From: Martin Yale Engineering

Date: 5-November-2013

Subject: 2051 Folder, Instructions for replacement of original style home flag sensor with WRA2051144 retro-kit ('new' style home flag sensor)

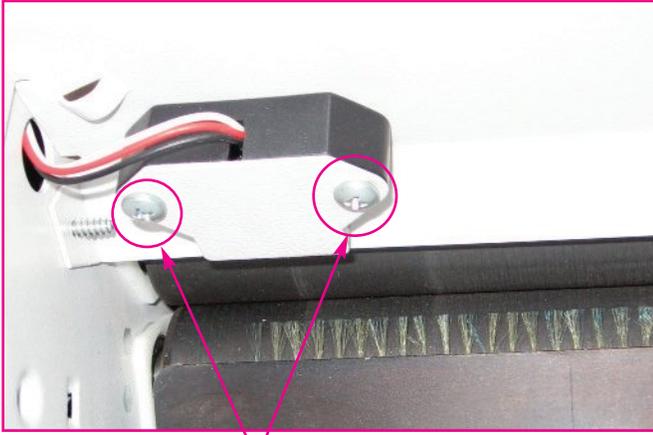
Identification: The first step in fold table sensor replacement is identifying the sensor to be replaced and confirming that it is the 'old' style. Pictures of both the old and new style sensors are given below for reference. If the part being removed is the same style as the replacement, the software set-up modifications presented below are to be ignored.

Original style 2051/2045 home flag assembly---Note 2 piece arrangement of sensor/housing.

New style (WRA2051144) replacement home flag assembly---Note 1 piece construction.

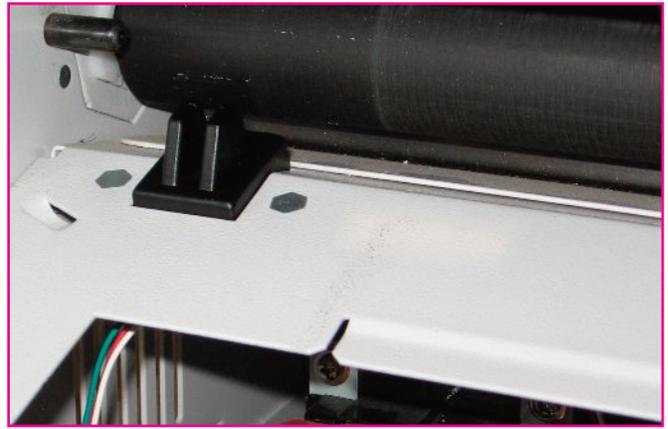
Sensor replacement: *WARNING: Unplug the Folder before performing any service on it.* Removal and replacement of the home flag sensors is largely self-evident by inspection. Replacement of both involves removing (2) philips mounting screws and unhooking its electrical connection. Removal of the 2nd fold table home sensor requires removal of the access panel located under the 2nd fold table. Removal of the 1st fold table home flag sensor may require removal of the folder's front cover in order to access its electrical connector.

1st Fold Table Home Flag Sensor mounting screws

2nd Fold Table Home Flag Sensor-Mounting screws are underneath

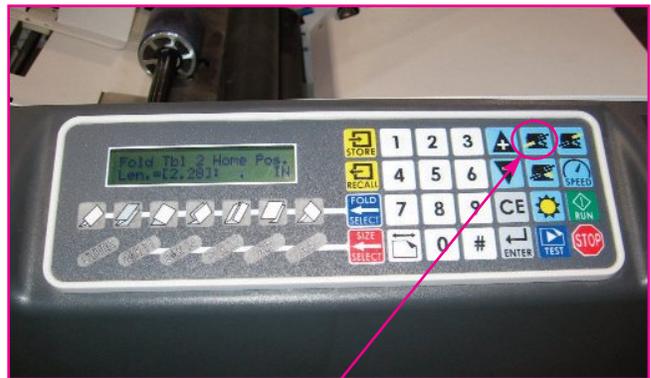
1st Fold Table offsets screen in diagnostic #7

2nd Fold Table offsets screen in diagnostic #7

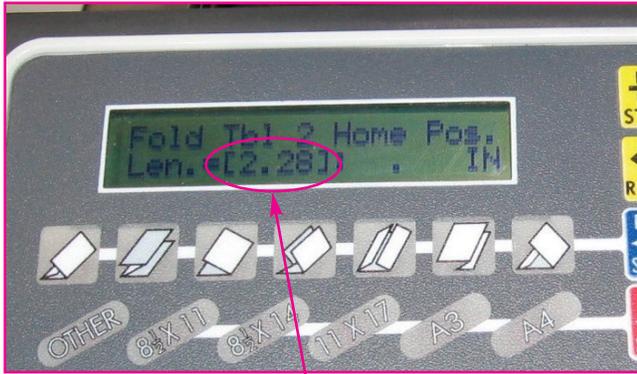
C. When the fold table button is pressed a screen appears that reads: Fold Tbl X Home Pos. Len.=[X.XX]: . IN. Record the bracketed value on the display for 'X.XX'. It should be a number from approximately 2.27 to 2.30. Once you record that number, add .05 to it and enter that number on the display by using the keypad. For example, if the number given on the display is '2.28', add .05 to that to get 2.33. Then type the '2.33' value on the display. Once the new value is on the display press 'Enter'. If you replaced the first fold table home flag, you have finished with the software set-up and can move onto step 'E' below. If you replaced the home flag sensor for fold table #2, perform step 'D' below.

Offset value screen-Record number in brackets

New value entered on display via keypad
